E8362CH85-01

S E R V I C E N O T E

E8362CH85 PNA Microwave Network Analyzers

A new touchscreen display inverter shield is available to improve PNA noise floor performance.

Figure 3

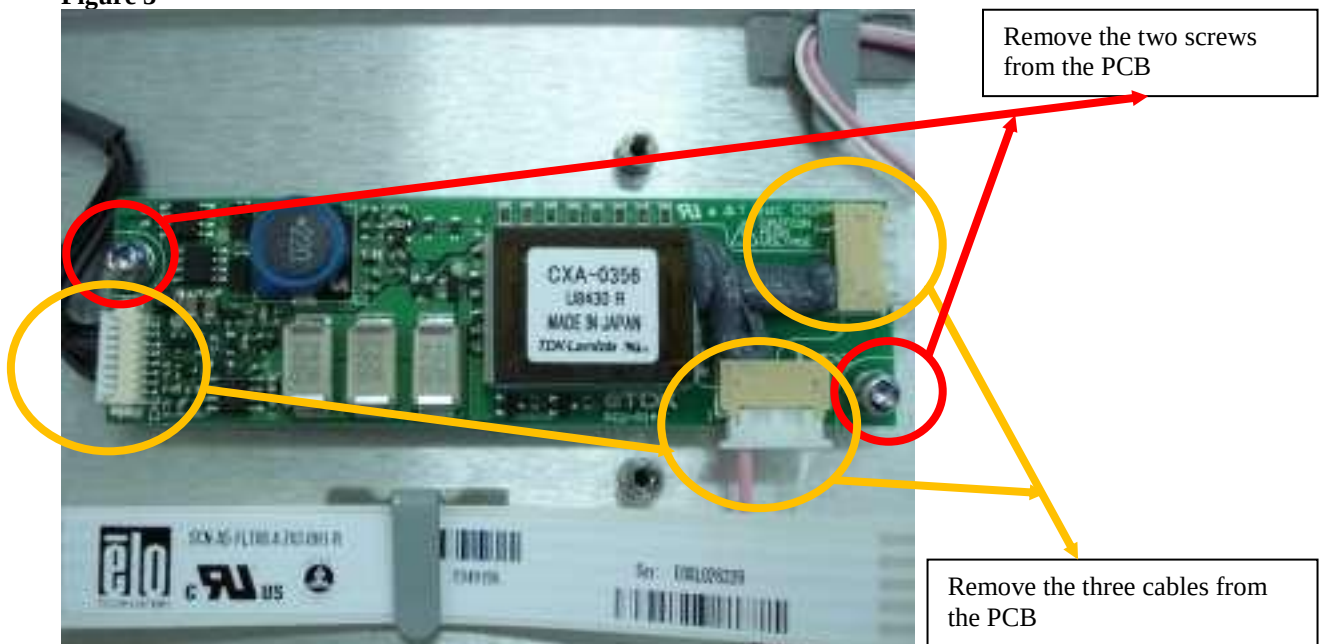
10. Remove the two screws from the PCB shown in Figure 3, using a T-10 wrench.
Disconnect the three cables connected to the PCB.
